DEVELOPMENT REVIEW BOARD  
SUPPLEMENTAL SUBMITTAL

PROJECT NO. PR-2020-004604

**To:** Jolene Wolfley and DRB Members, City of Albuquerque  
**From:** Michael Vos, AICP, Consensus Planning, Inc. *MV*  
**Date:** January 22, 2021  
**Re:** Allaso Vineyards DRB Comment Responses (PR-2020-004604)

**RE: Allaso Vineyards Apartments  
Conceptual Drainage Report  
Engineer's Stamp Date: No Engineer's Stamp Date  
Hydrology File: C20D086**

Sheet C-101

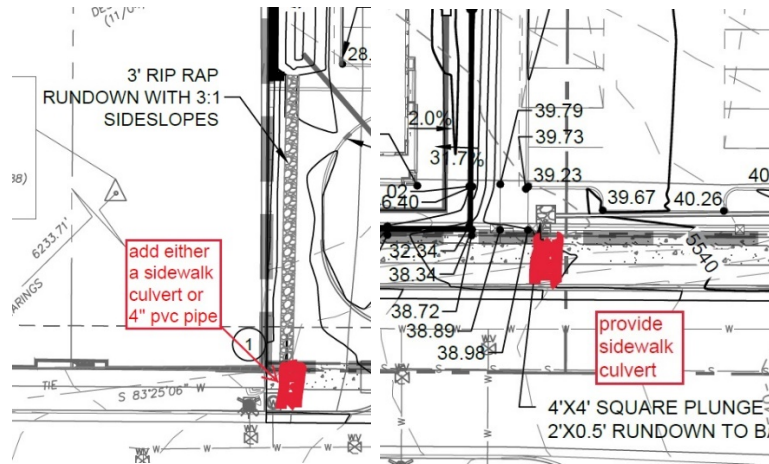
1. Stormwater discharges across the sidewalk are not allowed on collector roads and above; provide sidewalk culverts or drain lines through the curb. (See below)

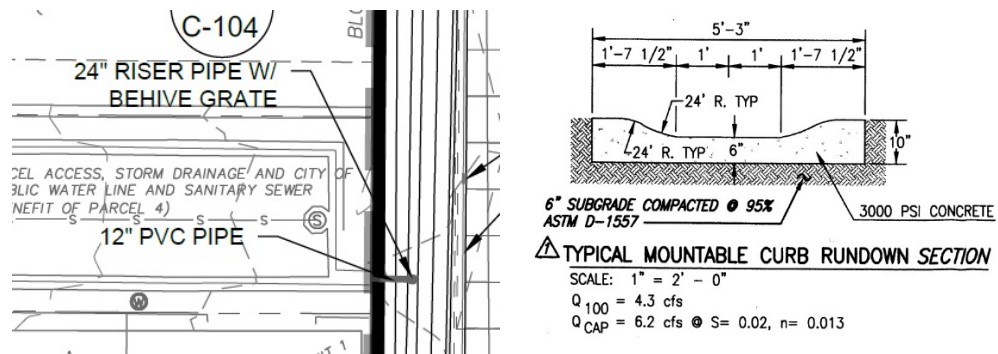
- Please show in more detail as how the proposed 12" PVC will be outfall into the existing mountable curb rundown (see below). A section showing the riser pipe with all needed elevations may be of some help.

ROUNABOUT DETAIL  
SCALE: 1" = 20'

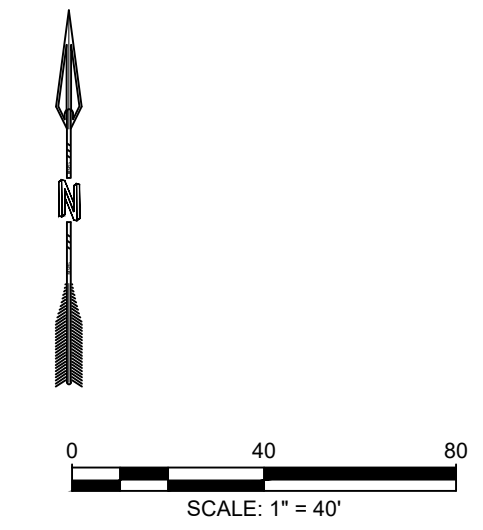
- a. *Understood.*
3. Provide exhibit showing the alternative of a roundabout to make sure that the configuration

does not conflict with the proposed site plan.

- a. A roundabout exhibit has been included with the resubmittal to show that no conflicts will occur.*
4. Show drive entrances opposite of site along Holly to demonstrate lack of traffic circulation conflict.
